SUNDRY NOTICES AND REPORTS ON WELLS

SJ 30-5 Unit #29A

San Juan 30-5 Unit # 29A

Conditions of Approval

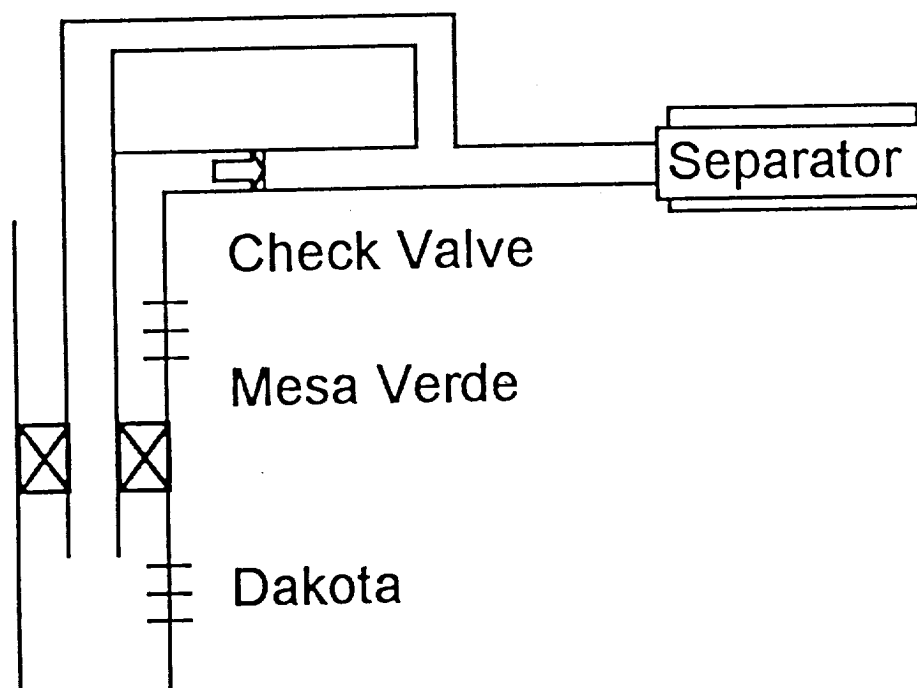
The Mesaverde will be flowed by itself for at least 24 hours (Dakota SI) every 1 month to determine MV production rate. Dakota will be allocated amounts above that allocated to MV. The Mesaverde will be produced through the tubing/casing annulus, while the Dakota will continue to flow through the tubing. The streams will mix just before entering the separator. A check valve will be placed in the MV surface piping to prevent back flow from the Dakota (see attached schematic).

1. The Mesaverde shall be flow tested for a minimum 24 hours once a month.
2. The flow-test must be conducted at the same pipeline pressure that the mixed product stream produces against.
3. All allocation for the surface commingling must be done on a BTU basis.
4. You must notify our office when surface commingling stops.
